**TOWN OF HERNDON, VIRGINIA
HISTORIC DISTRICT REVIEW BOARD WORK SESSION AGENDA
JULY 6, 2022
HERNDON MUNICIPAL CENTER
LARGE CONFERENCE ROOM, 2nd Floor
777 LYNN STREET
7:00 P.M.**

3. **APPLICATION FOR AN ALTERATION TO AN EXISTING STRUCTURE, HDRB #22-006**, to consider an application for rooftop equipment screening located at 771 Elden Street, Herndon, Virginia, further identified as Fairfax County Tax Map numbers 0162 02 0076, 0162 02 0077, and 0162 02 0078, and located approximately 125 feet east of the intersection of Elden Street and Center Street. This property is zoned as CC, Central Commercial District. Owner: Elden Market LLC. Applicant/Agent: Michael Wijdoogen, MW Architects.

Title: HDRB #22-006; Alteration to an existing structure; 771 Elden Street

② Proposed Front Elevation
1/4" = 1'-0"

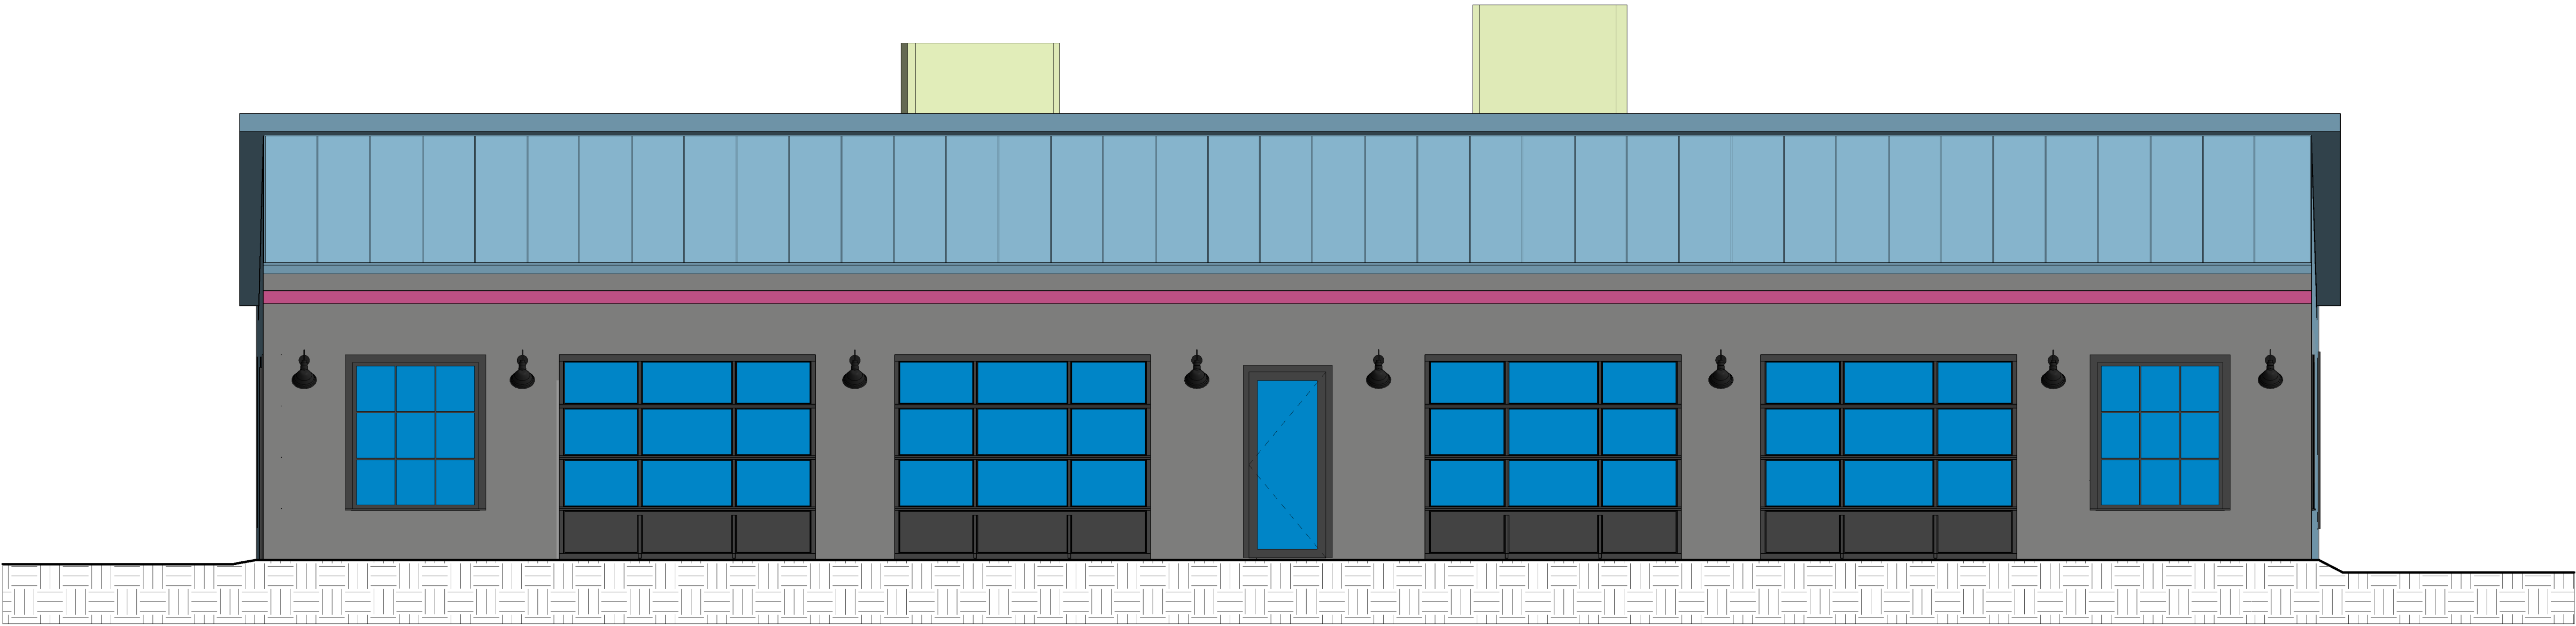
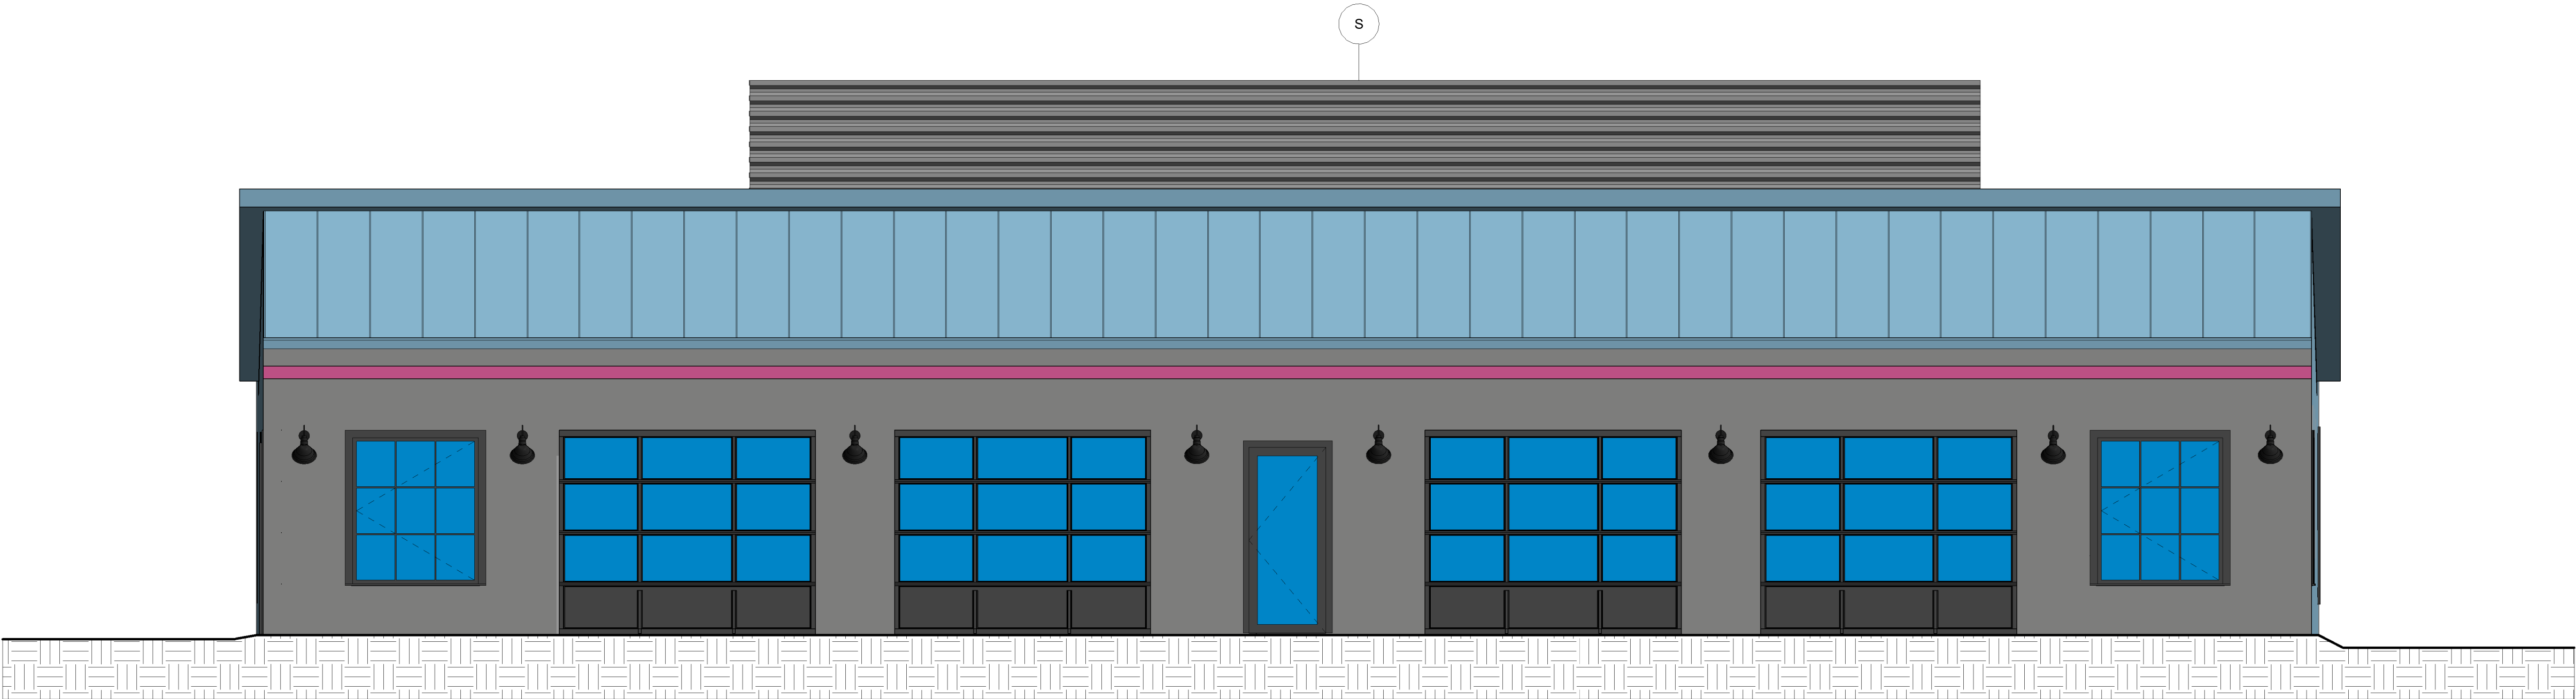
- Color. It is difficult to understand from the renderings how the musket gray color will look in relation to the two tones of blue, and the gray on the existing building. The renderings do not appear to show accurate colors for the existing building. In addition to this, the material information provided for the corrugated metal paneling does not include color information. Staff has asked the applicant to provide clarification regarding the color of paneling and how it relates to the existing building.

- Size and measurements. The submitted drawings do not include measurements for the structure. It would be helpful to know the height and length in order to understand the impact of the screening in relation to the overall massing of the building. Staff has asked the applicant to clarify the height and width of the enclosure.

- Edge treatment. The renderings do not describe how the screen edges are treated. This is an important aspect of the design and success of a screening enclosure of this nature, and will affect how finished or complete it looks when installed. Staff and the board need to understand how this is addressed.

- Alignment. The screening enclosure is not centered with the façade of the existing building. Because the rest of the façade is very symmetrical, the asymmetry of the screening enclosure looks incongruent and not purposeful. Staff suggest that this be addressed by centering the enclosure with the front façade.

② Proposed Left Elevation
1/4" = 1'-0"

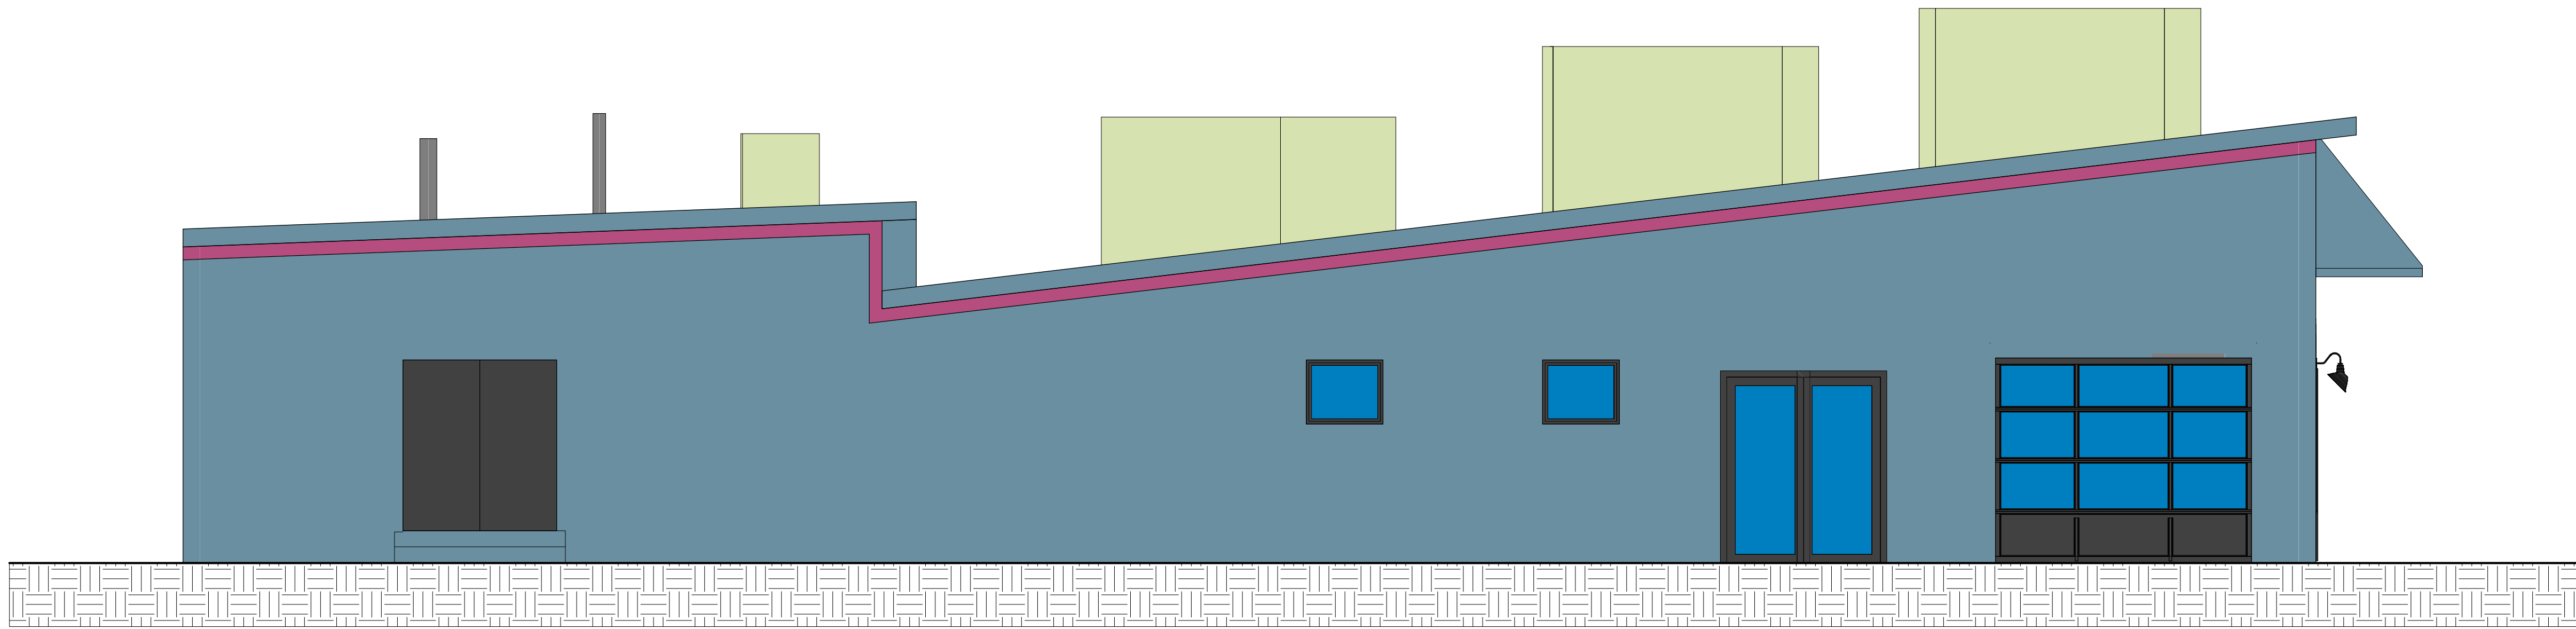
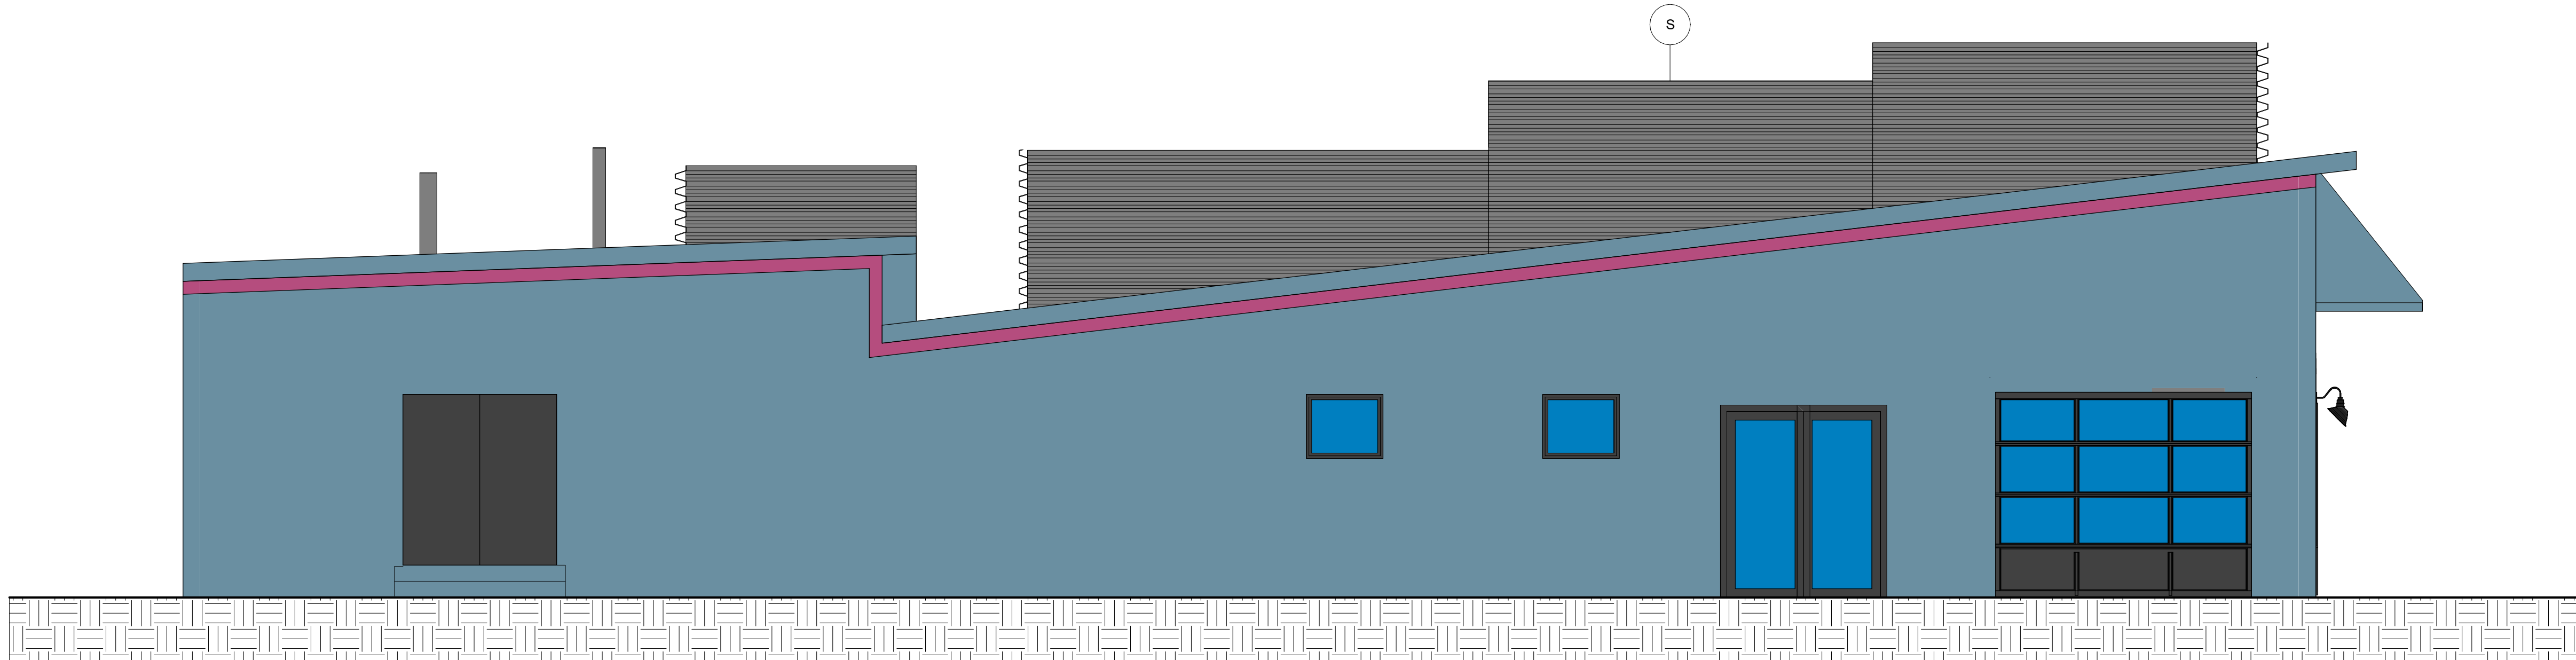
3. The east and west sides of the screening display prominent step-down design in order to compensate for the incline of the roof. The board may wish to discuss with the applicant a profile for the screening that follows the primary structure roofline instead of the step-down design. Staff believes that this could help minimize the visual impact of the screening enclosure.
